**PRELIMINARY DRAINAGE REPORT
FOR
STERLING RANCH FILING NO. 5**

**November 2023
Project No. 25188.16**

**Prepared By:
JR Engineering, LLC
5475 Tech Center Drive, Suite 235
Colorado Springs, CO 80919
719-593-2593**

STERLING RANCH FILING 5 EXISTING DRAINAGE MAP

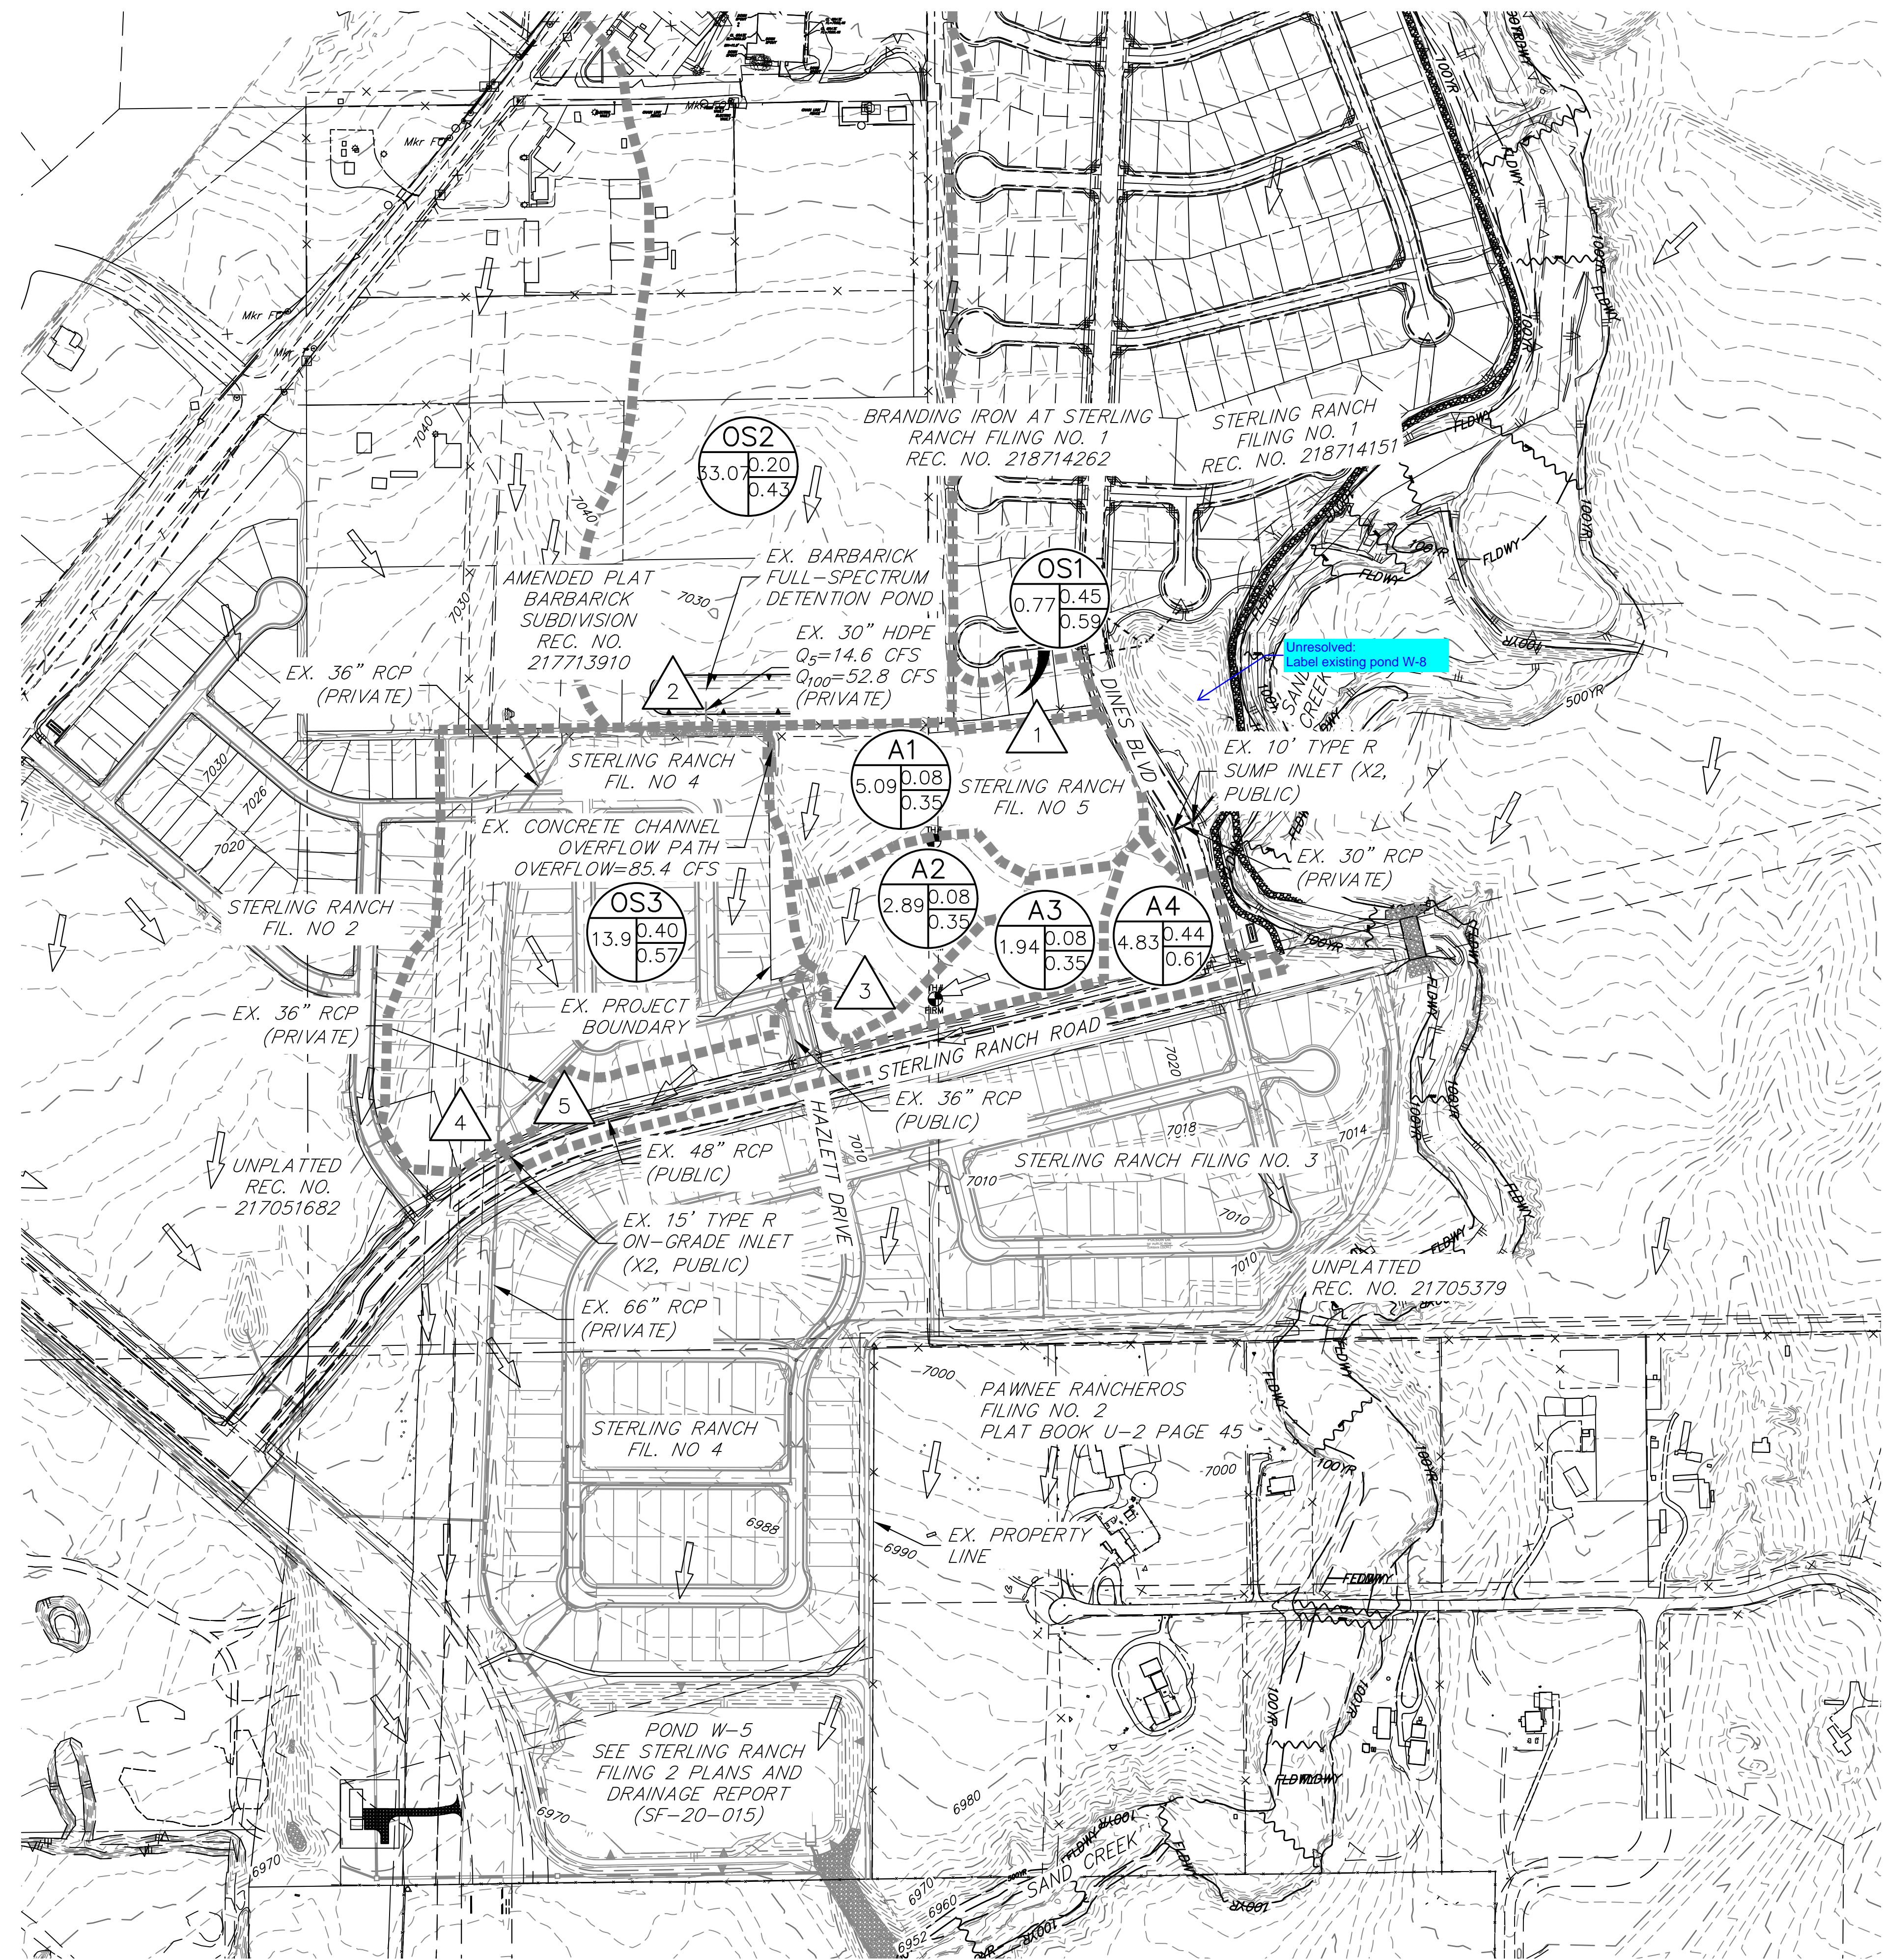
Unresolved:
Show and label proposed wall along Dines and Sterling Ranch. Will it impede drainage, is a swale or weep holes needed?

Unresolved:
Add street names
